Assessment report to Sydney Central City Planning Panel

Panel reference: PPSSCC-29

DA number	SPP-19-00008	Date of lodgement	26 July 2019
Applicant	Good Luck Plaza		
Owner	Good Luck Plaza (Blacktown) Pty Ltd and Good Luck Blacktown Centre Pty Ltd		
Proposed development	Integrated Development Application for staged construction of a part 15/part 16 storey shop top housing development being 56 m high, comprising 227 residential apartments, 7 basement parking levels, a supermarket, 13 retail tenancies, a child care facility, landscaping and public domain treatments		
Street address	5-19 George Street, Blacktown		
Notification period	11 September to 11 October 2019	Number of submissions	2

5 DUPLEX SECTION - CROSS VENT
1:100

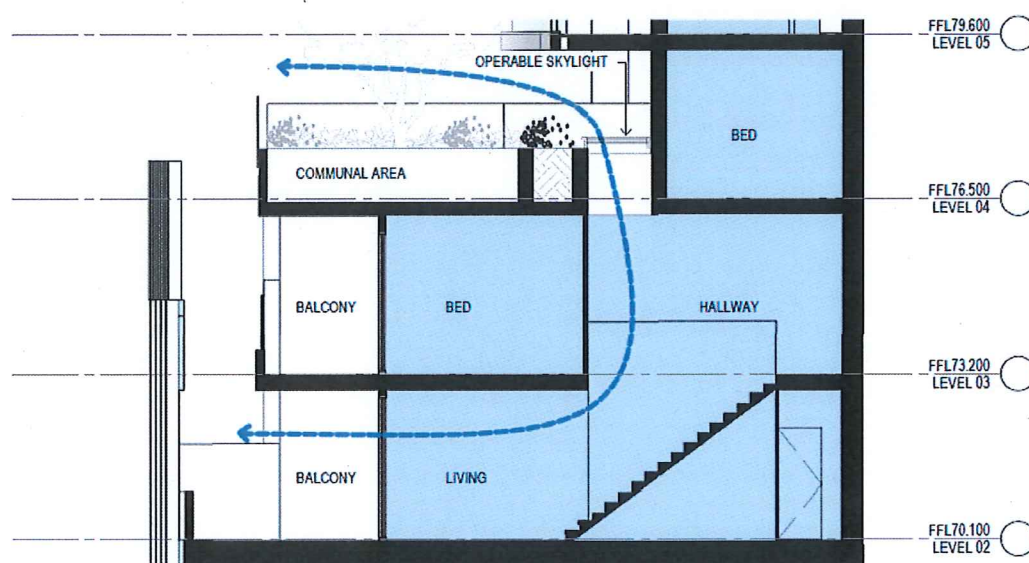
7.5.1 To achieve natural cross ventilation to at least 60% of apartments in the first 9 storeys, as required by Part 4B Natural Ventilation of the ADG, the applicant seeks to provide roof vents to 4 double storey apartments in the eastern tower, being apartments 2B-12, 2B-13, 2B-14 on the 3rd storey and 1 single storey apartment on the 5th storey, 2B-24. The roof vents for the 2 storey units work because these are units on the outer wall that are stepped out and the vent opens to the floor that has no direct unit above it in the communal area. See cross-section below.

7.5.2 With regard to Unit 2B-24, it has a side height window to an open corridor which catches the western breeze and circulates it through the unit onto the north-west window of the unit.

7.5.3 To support this alternative technique for natural cross ventilation, the applicant submitted a Natural Ventilation Assessment report prepared by JHA Consulting. The applicant's justification is as follows:

7.5.4 The overall development is considered to achieve a suitable level of amenity through natural cross ventilation, subject to this alternate technique. The provision of units with mezzanine floors and skylights is recognised by the ADG as an acceptable solution and alternative under Objective 4B-2 'stack-effect ventilation'. This proposal provides variety in unit living options which is supported.
